Addendum No. 01

Project Name: SLCC Inclusive Restroom Addition

Project No.: 2022560.01

Issued: 12/5/2023

27 OCTOBER 2023 DEMOLITION

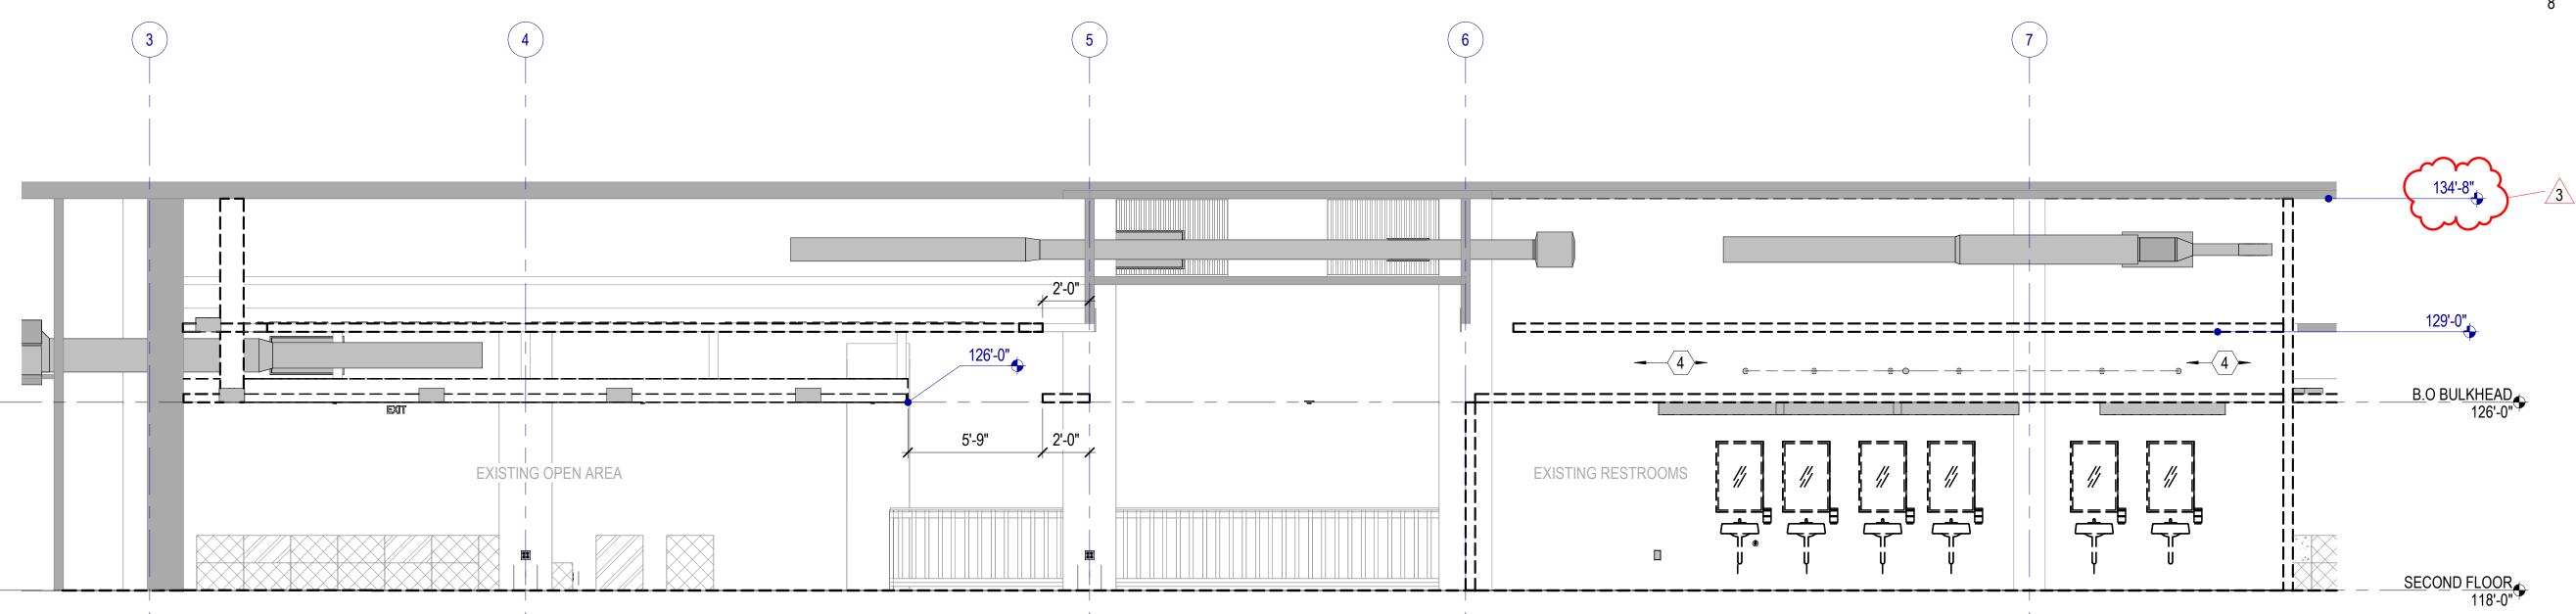
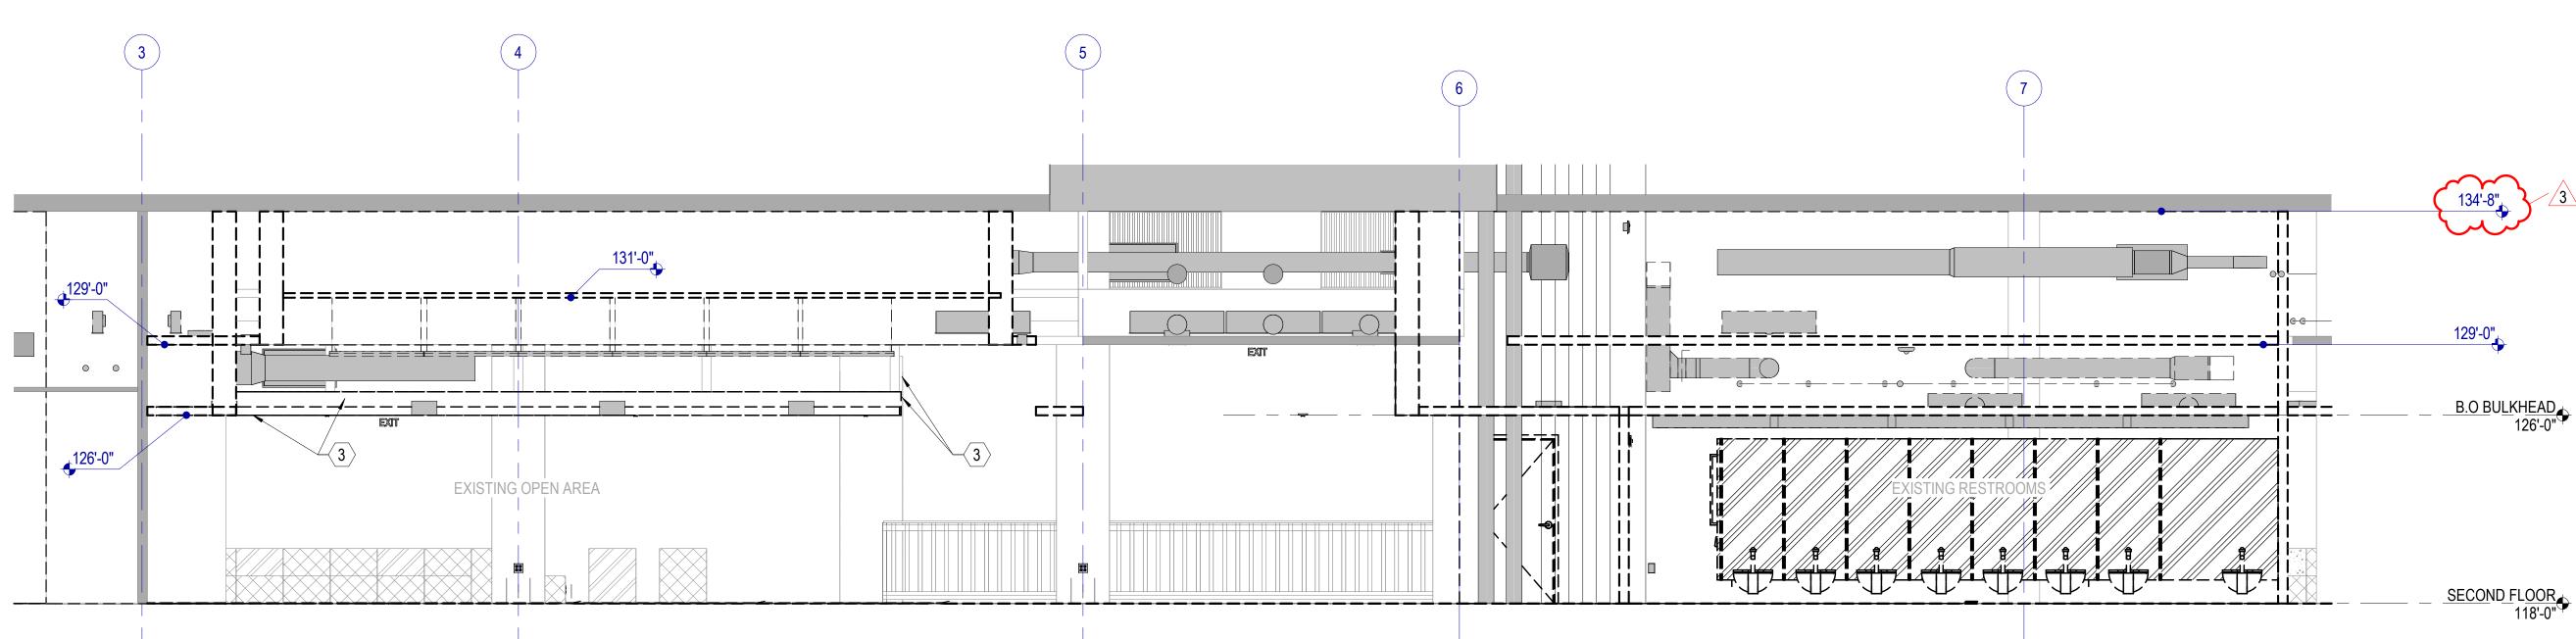
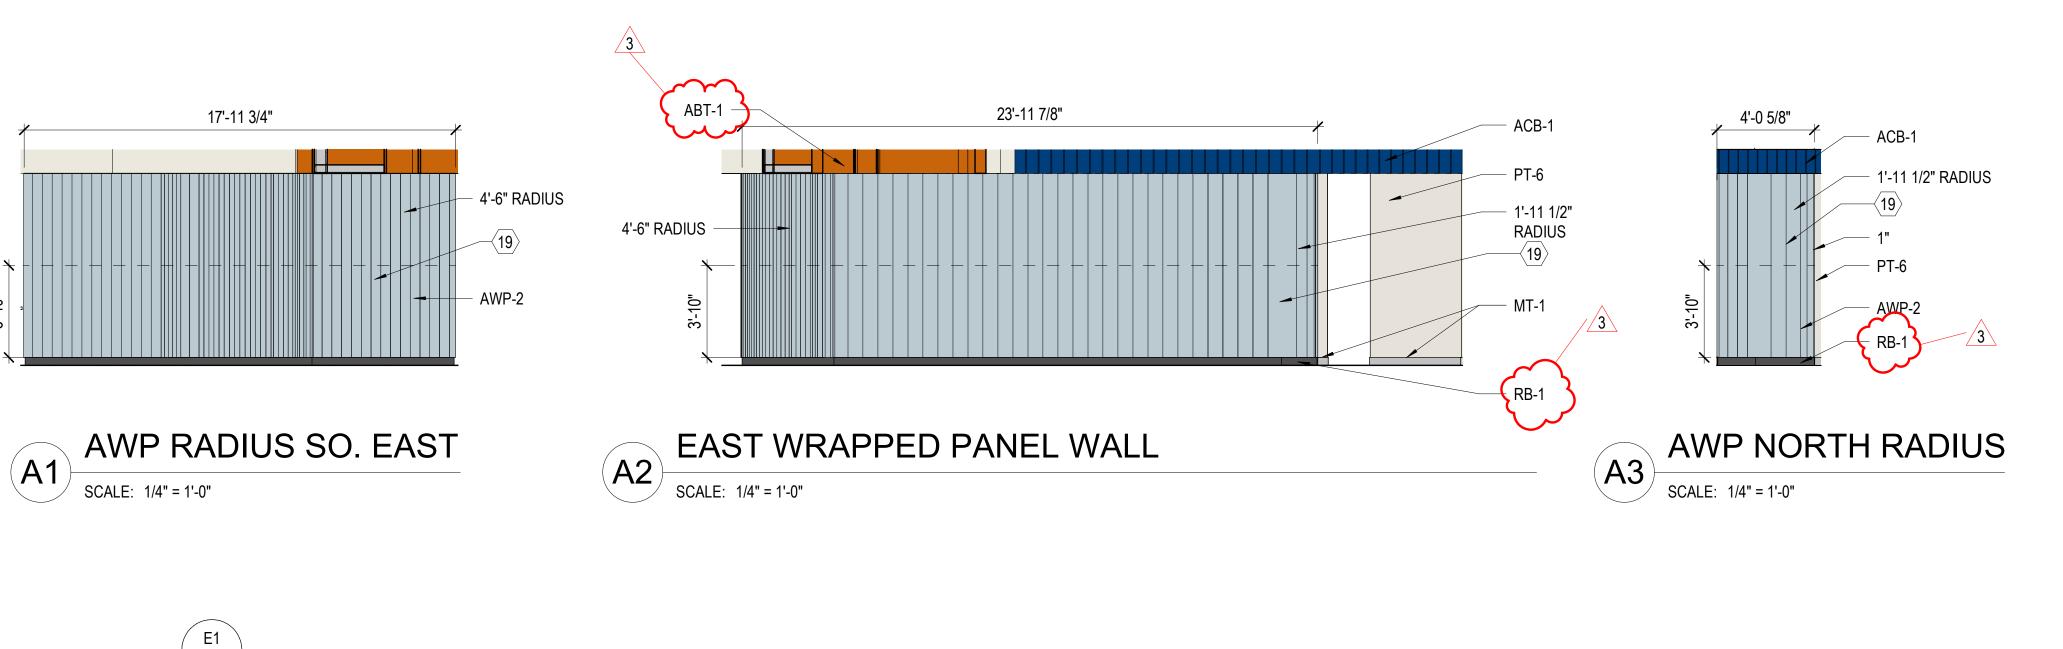
B1.4 Sheet AD301 – DEMOLITION PARTIAL BUILDING SECTIONS:

Deck elevation added to sections.

- 10. **Question:** Several walls are to be framed to deck. Can you please provide the deck height? SHEETS AD300 AND AD301 HAVE BEEN UPDATED TO INCLUDE THE ELEVATION OF THE ROOF DECK.

ELEVATIONS -INSIDE & OUTSIDE RESTROOM

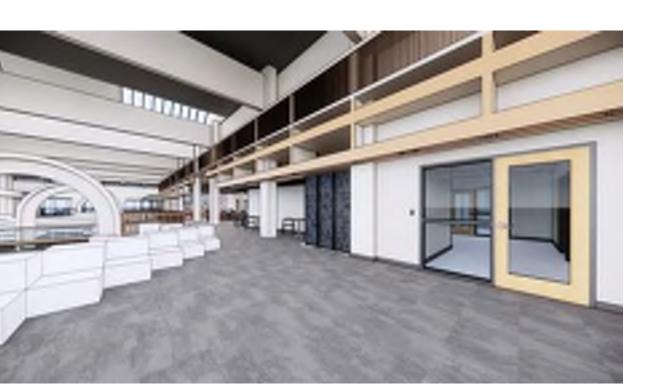
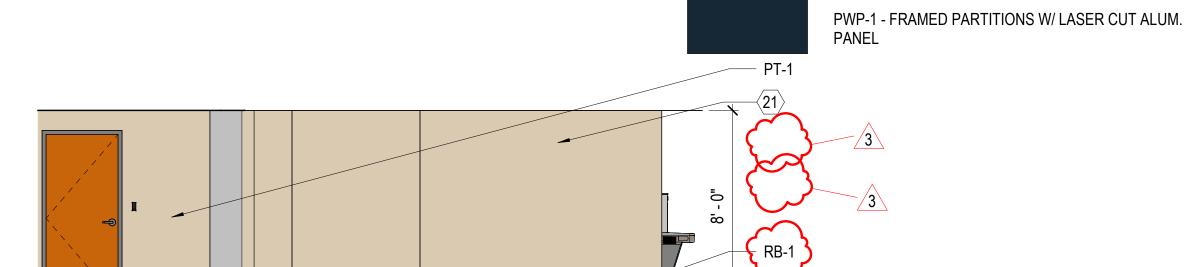
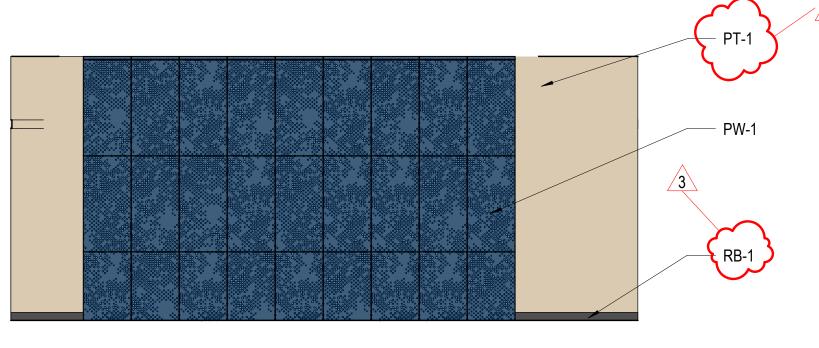
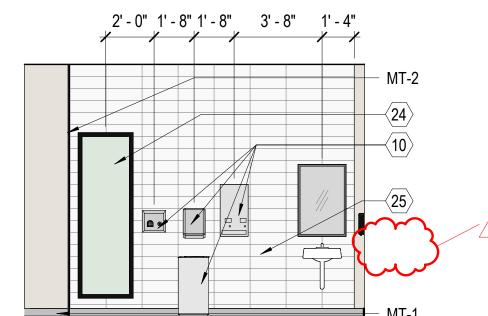
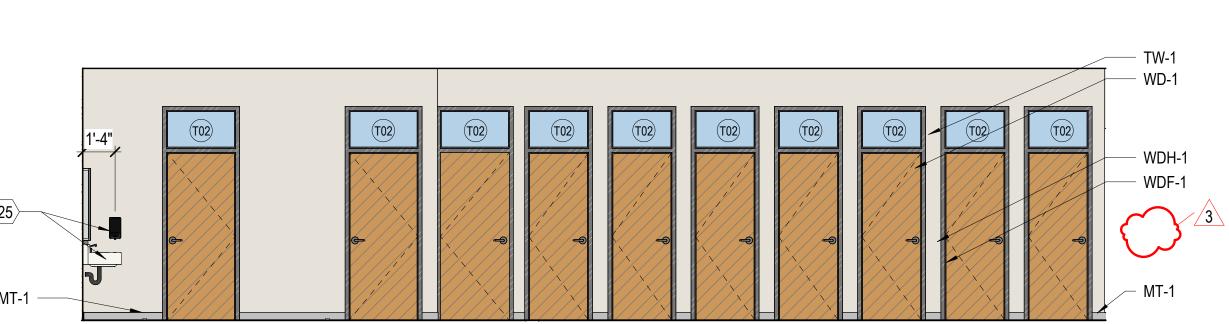
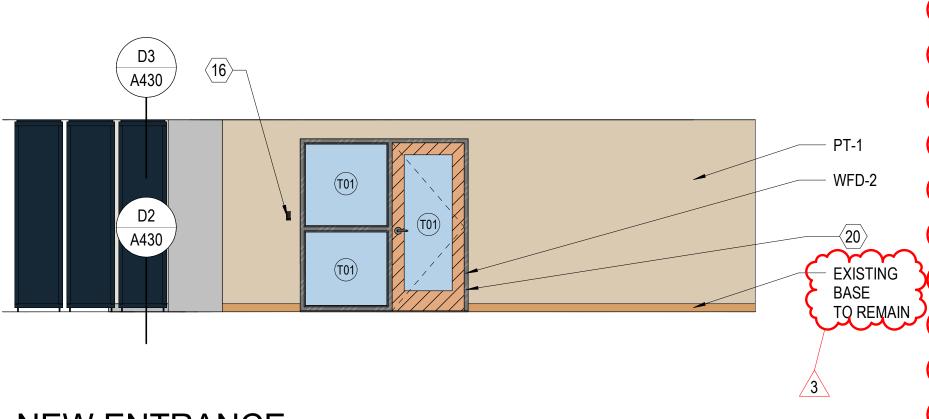
B1.5 Sheet A412 – INTERIOR ELEVATIONS – INSIDE & OUTSIDE RESTROOM:

Keynotes revised and RB-1 added to the legend.

- Question: Can you please clarify the location of the LAM-4 bench? Keynote 13 on E2&E3/A412 reference it, as well as the section reference on E3/A412, but these look to be in error. I can't find it on any elevations or floor plans. Please advise. THE BENCHES HAVE BEEN REMOVED FROM THE PROJECT. THIS LAM-4 IS NO LONGER BEING USED. DETAIL E2/A430 HAS BEEN REMOVED.

- 6. **Question:** Elevation D3/A412 calls out PWP-1 on the wall. This appears to be a mistake. Can you please advise? SHEET A412 HAS BEEN UPDATED KEYNOTES WERE REMOVED AND ADDED AS REQUIRED. THE PANELS ON THE WEST SIDE OF THE RESTROOM WERE REMOVED. THE PWP-1 ON D3/A412 WAS A MISTAKE AND NO LONGER APPLIES TO THIS.

- 8. **Question:** There are several areas that ACT-1 is called out that appear to be a mistake. E1/A430, A2&B1/A412, etc. Can you please clarify. THIS IS NOT ACT-1, THIS IS A P.E.T. TRIM THAT WRAPS AROUND THE BAFFLES ABT-1 "ACOUSTICAL BAFFLE TRIM". E1/A430 AND A2&B1/A412 HAVE BEEN UPDATED.

INTERIOR **ELEVATIONS -NEW ENTRANCE**

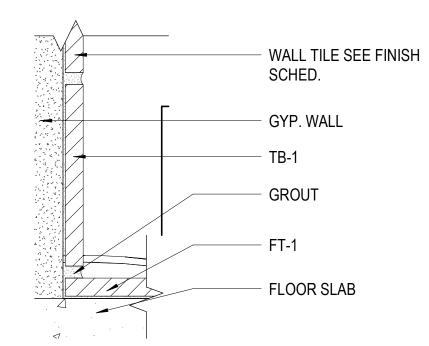
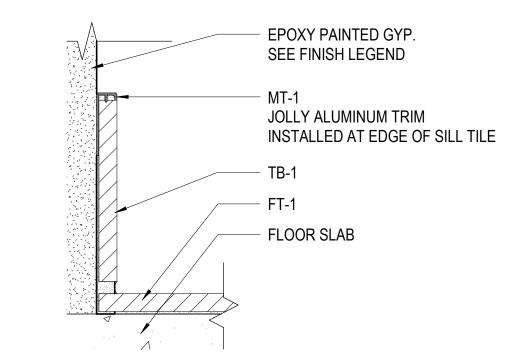
B1.6 Sheet A414 – INTERIOR ELEVATIONS – NEW ENTRANCE:

Keynotes revised, floor base styles have been clarified outside and inside the new suite entrance.

- 9. Question: Can you please clarify what base will be installed on the exterior side of all of the restroom walls? The elevations don't specify and the finish schedule and wall section says "existing", which isn't possible on the new walls. SHEET A640 HAS BEEN UPDATED TO SHOW NEW RUBBER WALL BASE WB-1 OUTSIDE OF THE RESTROOMS AND IN THE NEW SUITE ENTRANCE.

INTERIOR DETAILS

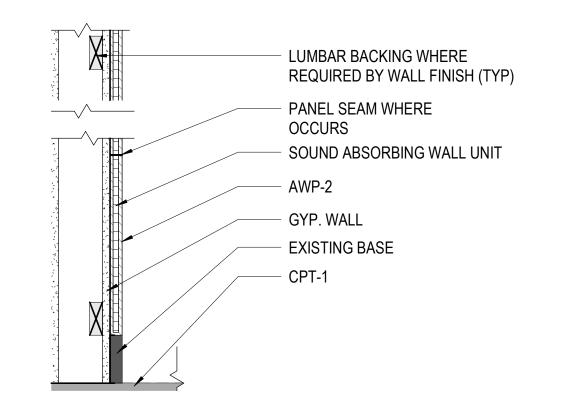
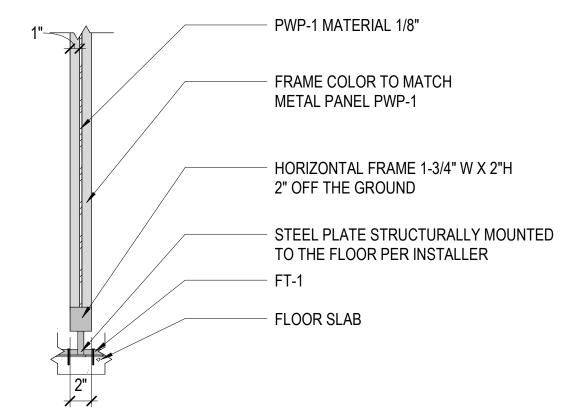
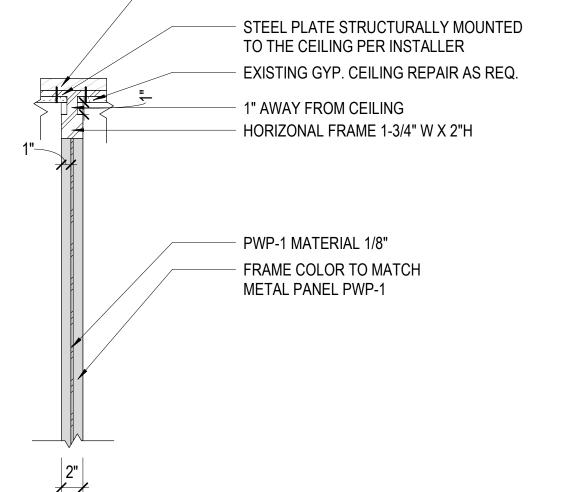
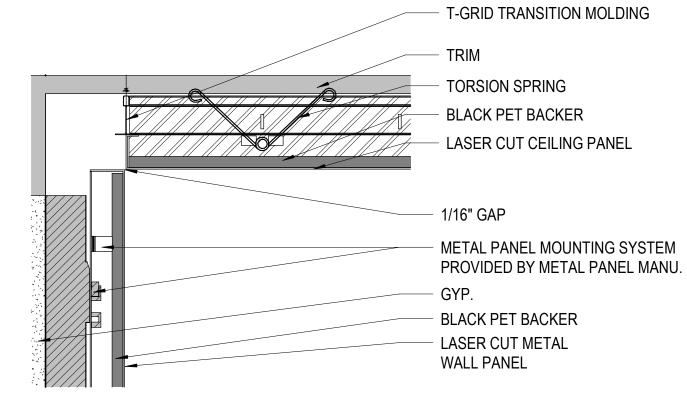
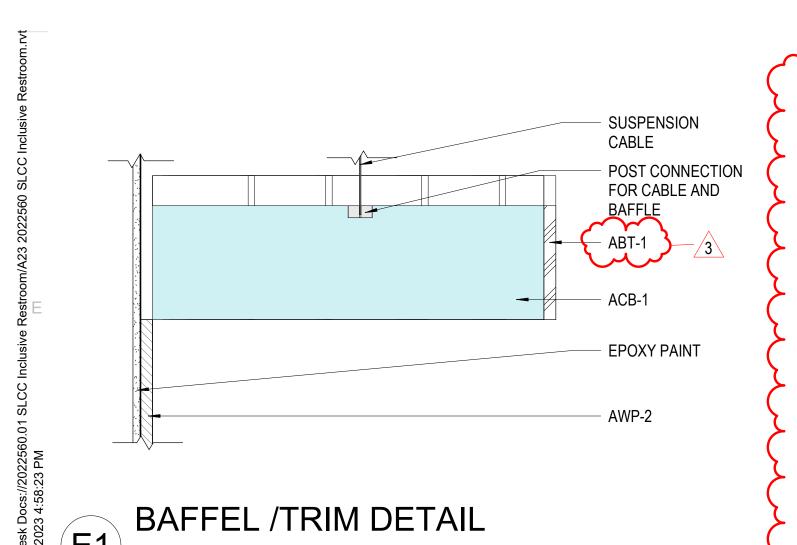
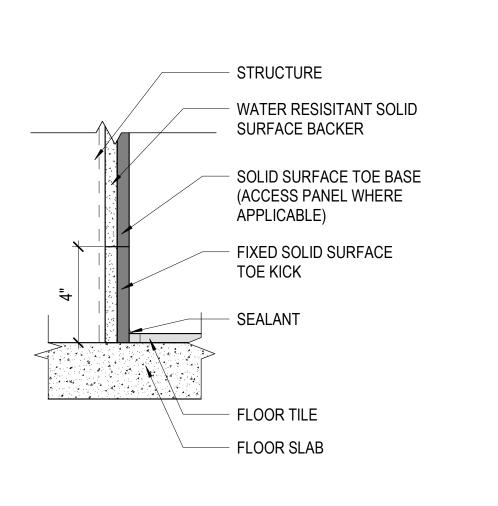
B1.7 Sheet A430 - INTERIOR DETAILS:

E1 detail note revised. Detail E2 deleted, not used.

- 14. **Question:** What is Door Type "L"?. Door type L is not shown on Sheet A600 door & frame types detail. SEE RESPONSE TO QUESTION 4.
- 15. **Question:** A430/E2 notes a bench but on 412 E3 I see where they direct us to this bench but there is no bench there. Can you direct me to where this bench is? BENCHES WERE REMOVED FROM THE PROJECT, SHEET A430 HAS BEEN UPDATED BENCH DETAILS AND REFERENCES HAVE BEEN REMOVED.

A600

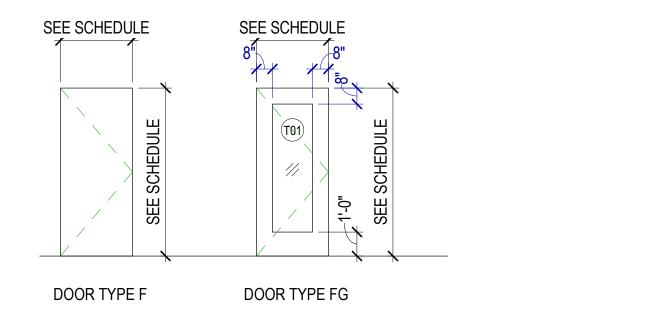
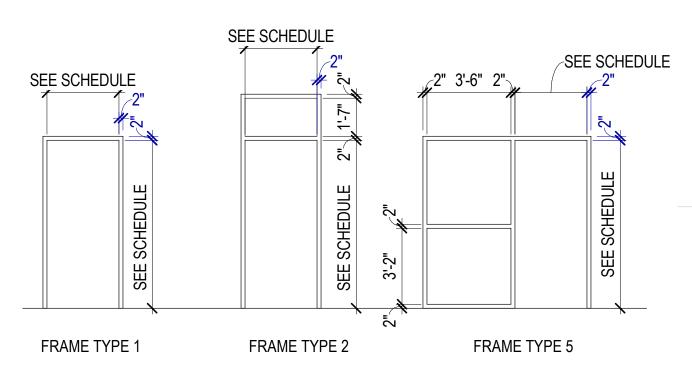
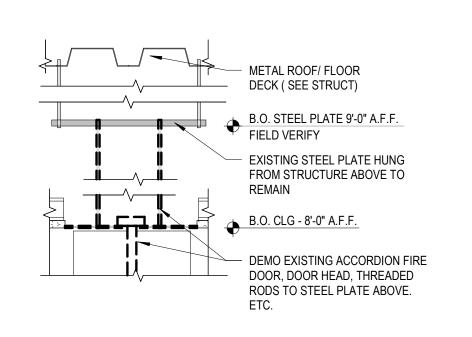
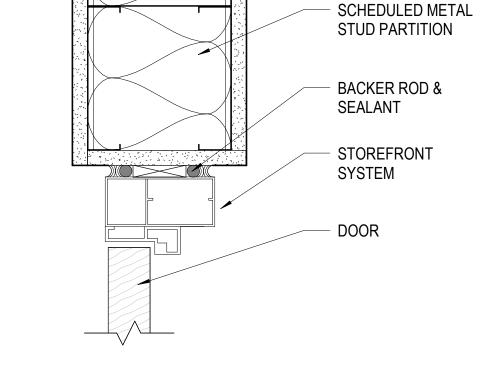
B1.8 Sheet A600 – DOOR SCHEDULE, WINDOW TYPES & DETAILS:

Doors 230J, 230K, and 230L revised to Type 'F'.

- 4. **Question:** In the door schedule, there are a few doors specified as Door Type L. There is no information on that door type. Please specify. SHOULD READ DOOR TYPE 'F'. SHEET A600 DOOR SCHEDULE HAS BEEN UPDATED.
